Errata: CS43L42 Rev. D**CS43L42 Low Voltage, Stereo DAC with Headphone Amp**

All references to the CS43L42 mentioned below shall be taken to refer to revision D of the CS43L42 product. The hardware revision code can be found in the 10-character field printed below the part number on each chip. The letter which appears as the fifth character from the right is the revision code (e.g. ZNACSD9926 is a Revision D part).

Figure 1. Pop Guard Fix

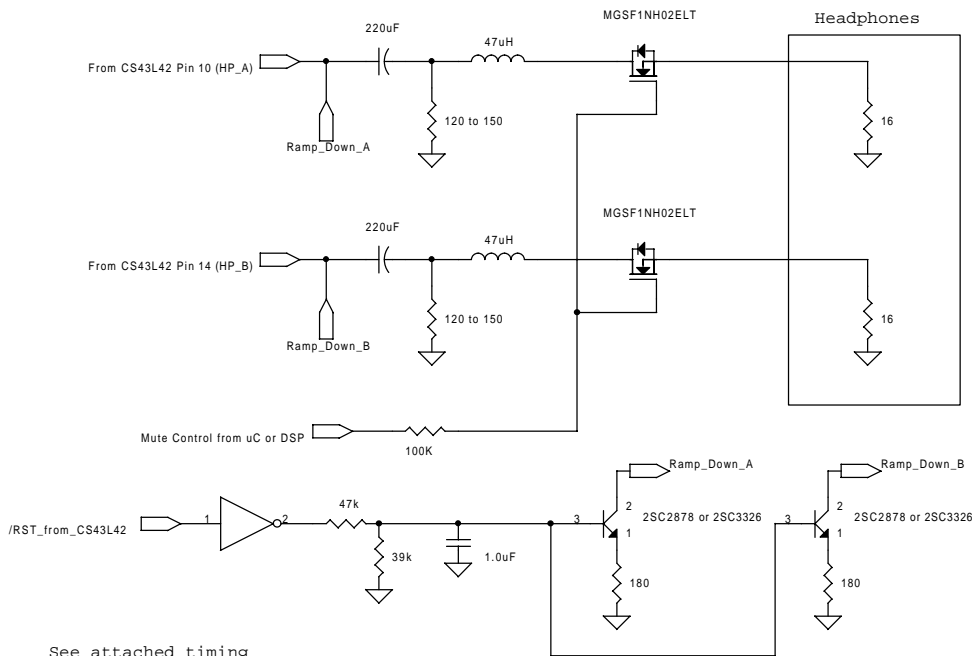
- The PopGuard[®] Transient Control does not function properly and will produce audible artifacts on the headphone and line outputs during power-up. A hardware fix is available for this issue. Please see Figures 1 and 2 for the headphone output fix. For the line outputs, please use the optional mute circuit shown in the CDB43L42 schematic to mask this problem.

- The PopGuard[®] Transient Control power-down ramp requires 5 seconds to prevent audible artifacts on the headphone outputs at the next power-up. A hardware fix is available for this issue, see Figures 1 and 2 for details. This fix will reduce the ramp down time to approximately 300 milliseconds.

The Motorola MOSFETs shown have been tested to work properly, however, an equivalent device may be used.

2SC2878 is in TO-92 package
2SC3326 is in SOT-23 package

The Toshiba transistors or equivalent will work best here. The device used must have a very low R_{on} (3 ohms or less).

Figure 2. Timing for Pop Guard Fix

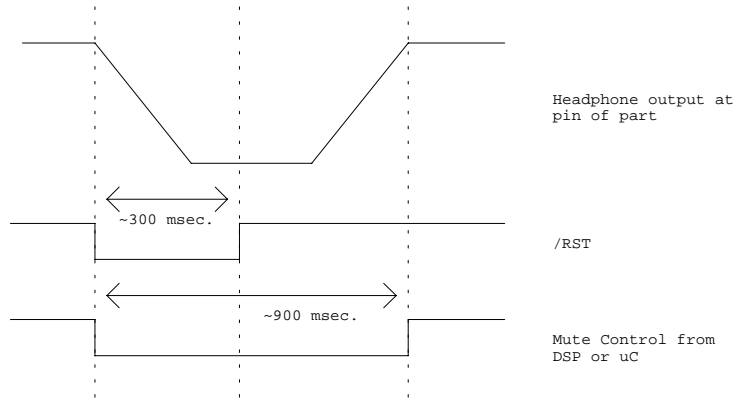
See attached timing diagram for /RST and the Mute control. Customer will need to generate the mute control from their DSP or micro-controller.
